DEVIATION REQUEST AND DECISION FORM

Project Name : CLOVERLEAF FILING NO. 2
Schedule No.(s) : 7124202236, 7124202239, 7123103007, 7124202238
Legal Description : SEE ATTACHED -- Exhibit B

A deviation from the standards of or in Section **ECM Ssection 3.3.1.J.2** of the Engineering Criteria Manual (ECM) is requested.

DP06 PROFILE
STA 0+00.00 TO 6+77.61

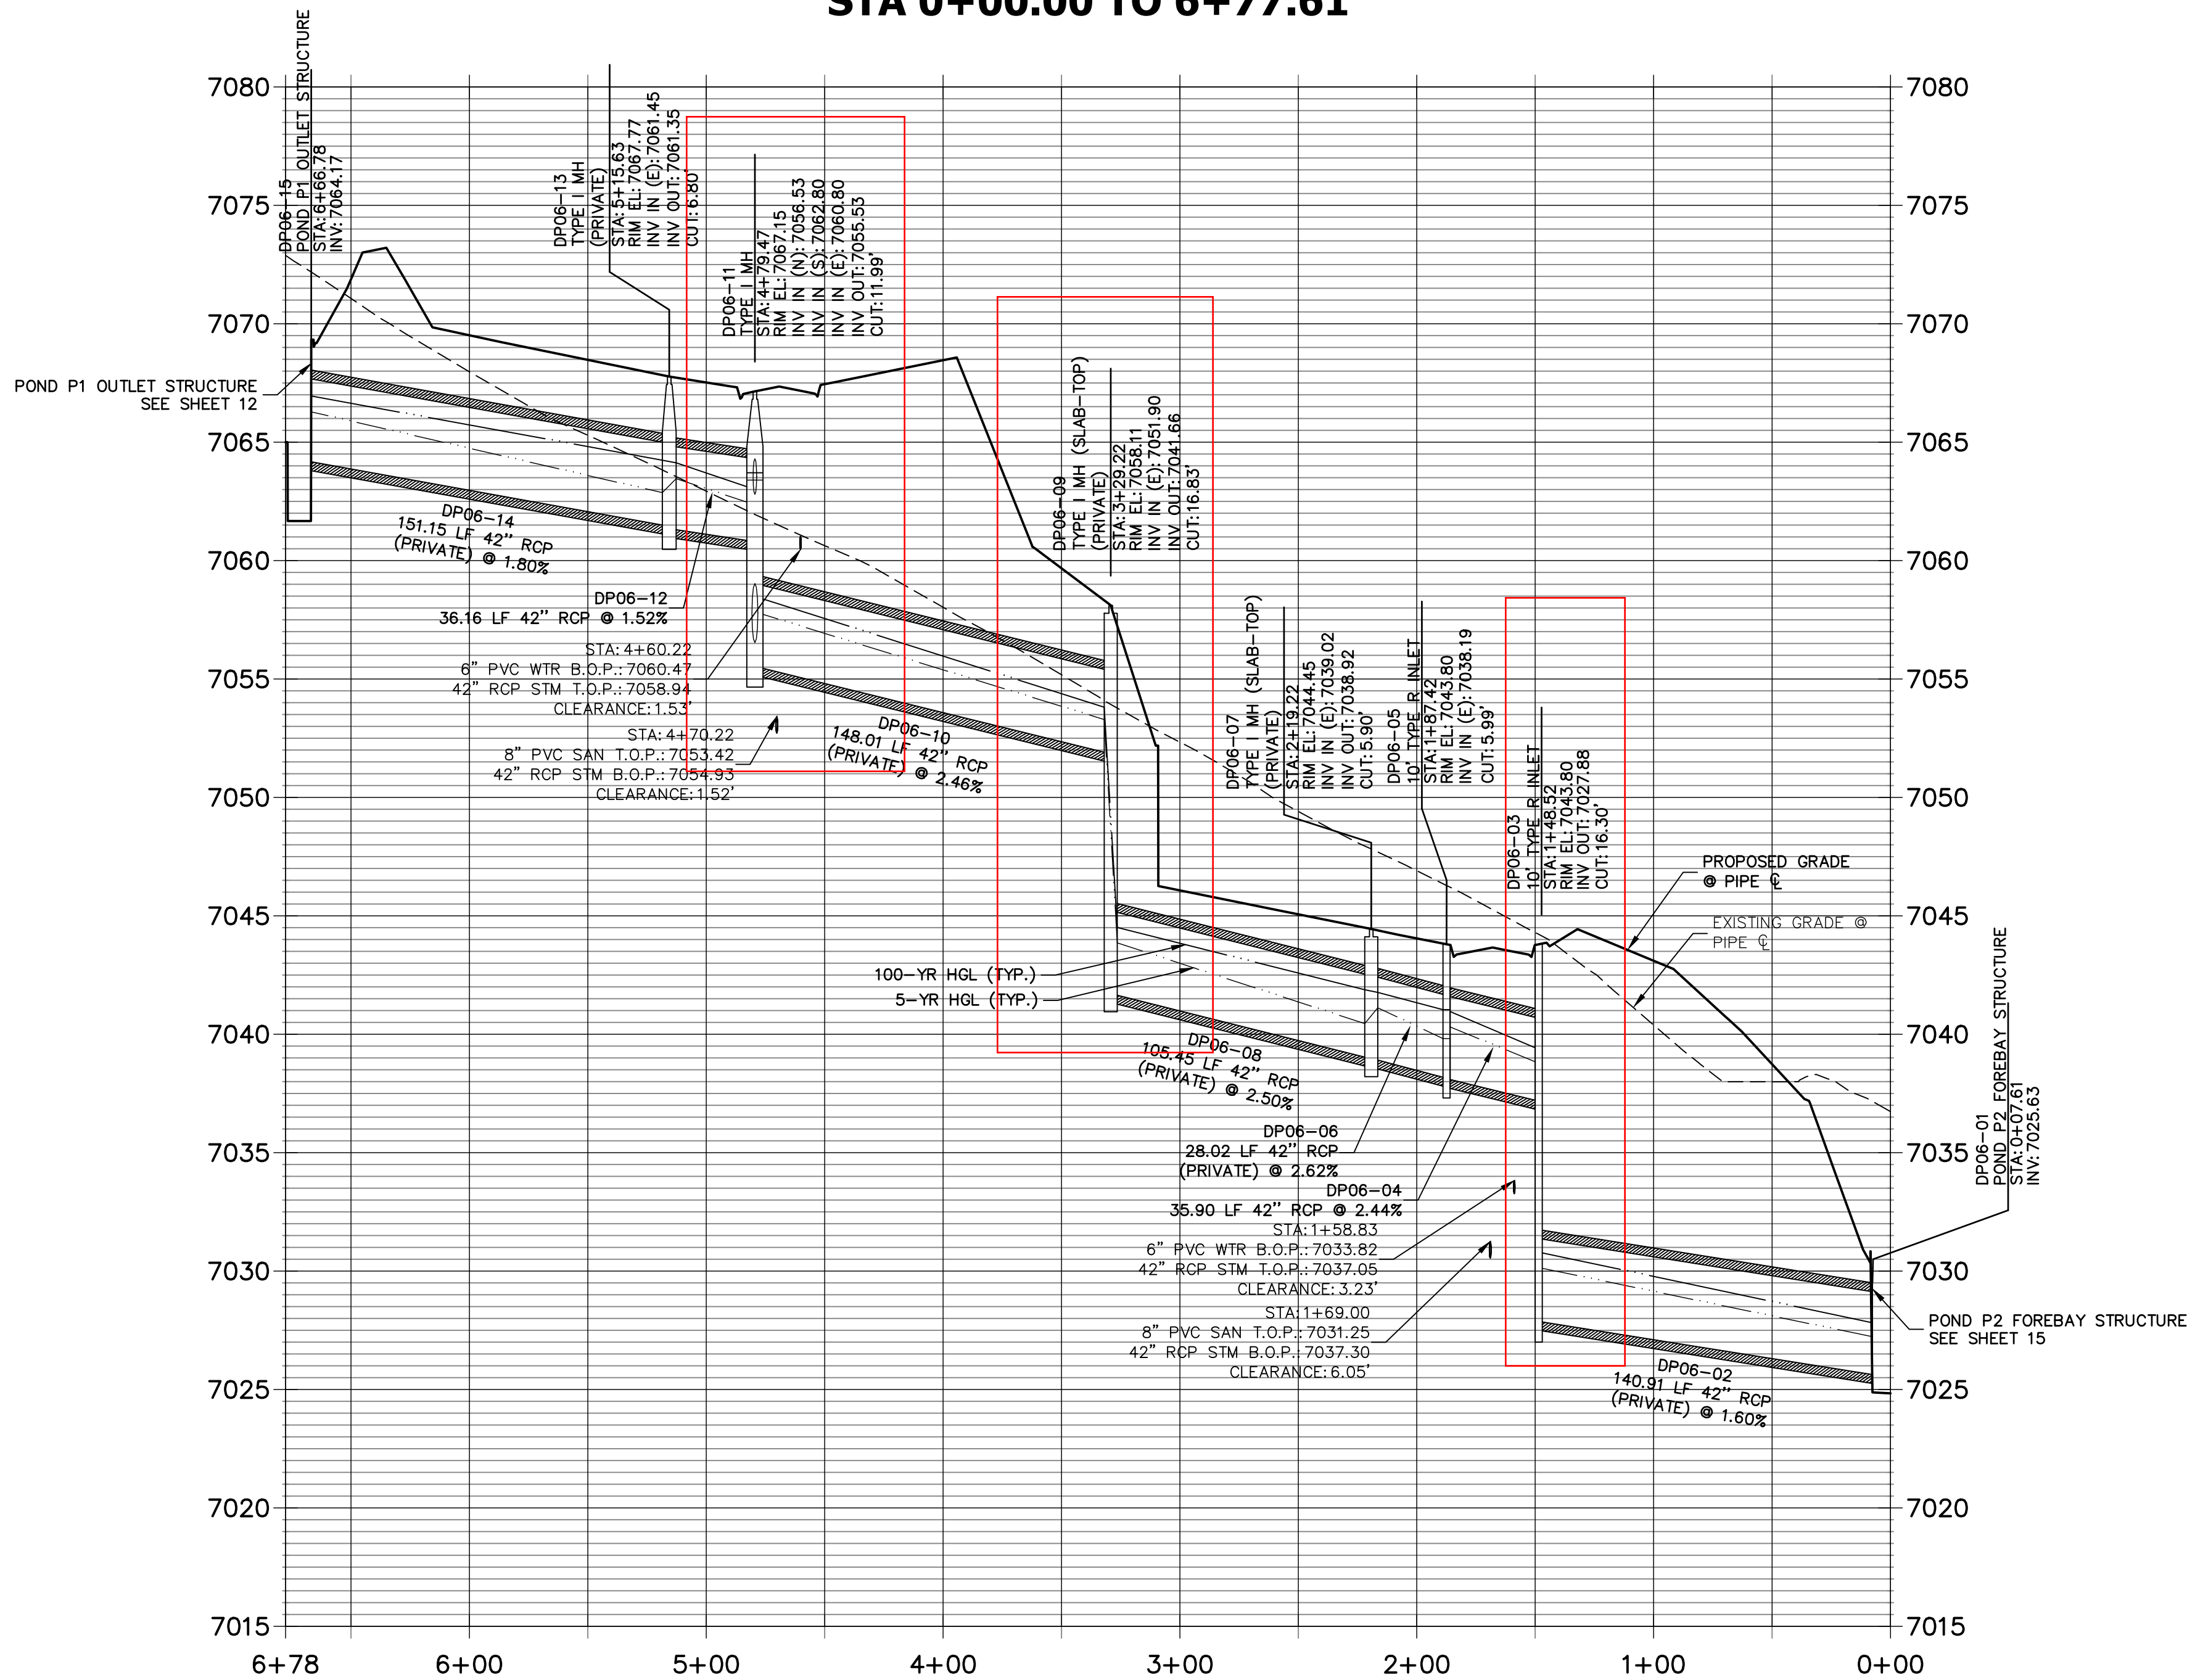
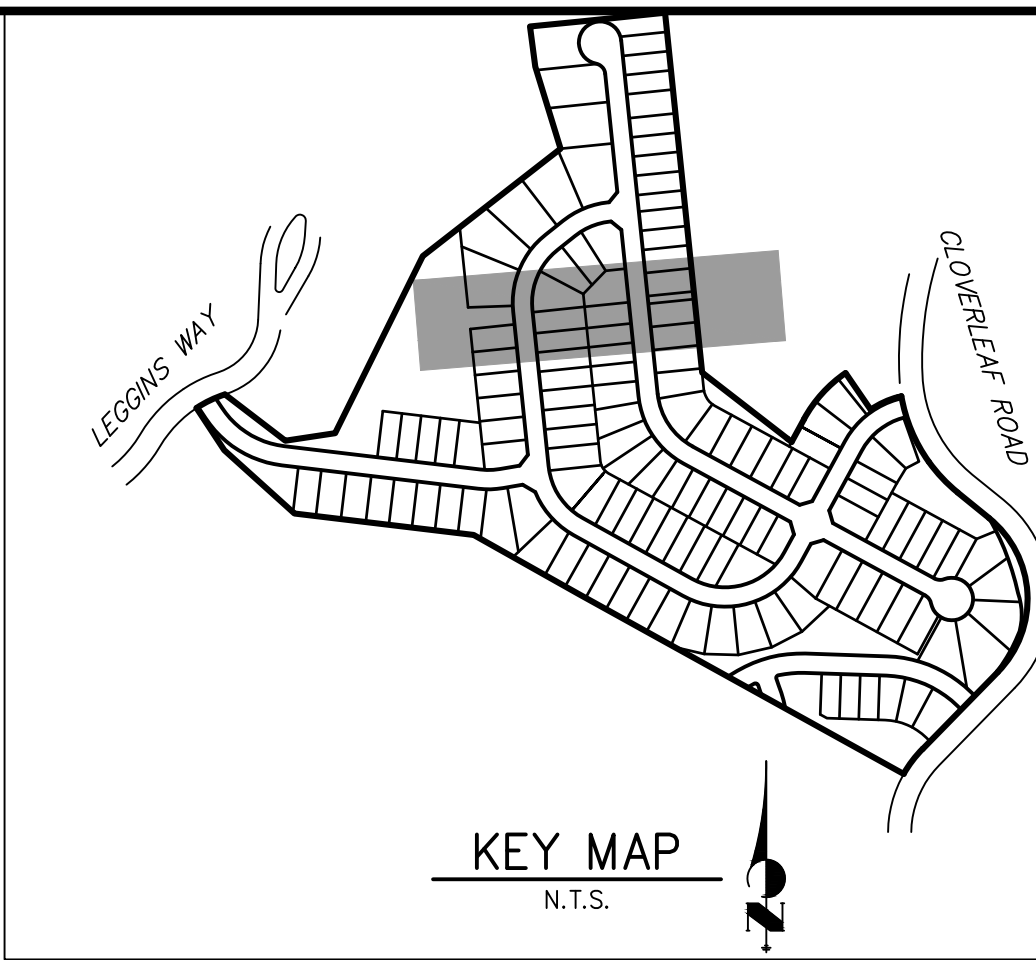
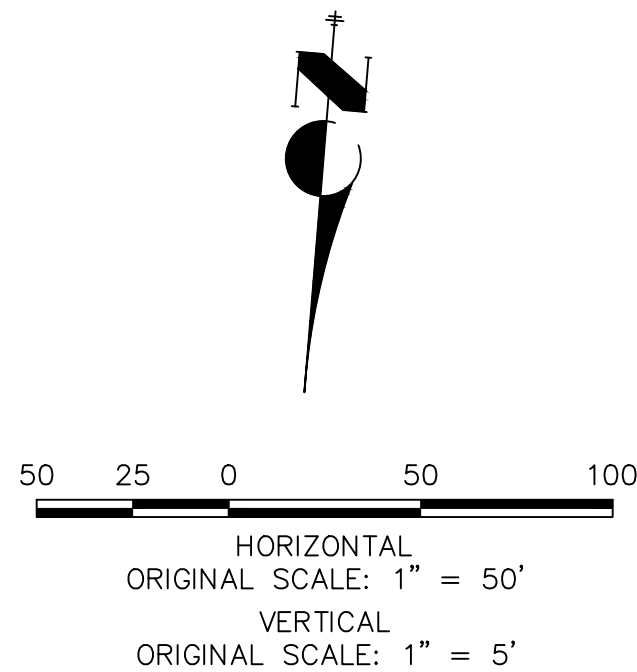
MH-DP06- 11 (5.3 ft. drop), MH-DP06-09 (10.3 ft. drop) and STR DP06-03 (Type R Inlet – 9.5 ft drop): Pond 1 to Pond 2 storm sewer. The change in grade between Pond 1 (the east offsite pond) and Pond 2 is approximately 40 feet in under 700 feet of pipe and to design the storm sewer to Section 3.3.1.J.2 would cause excessive velocities.

Drop manholes in excess of 1 ft. have been approved under the City of Colorado Springs DCM Volume 1, Chapter 9, Section 6.4 (regional standard) for similar situations within adjacent municipalities. Drops greater than 1 ft. require additional concrete strength and scour protection which is proposed with this design in the form of Class D concrete for the manhole and provision of a 1 ft sump for energy dissipation.
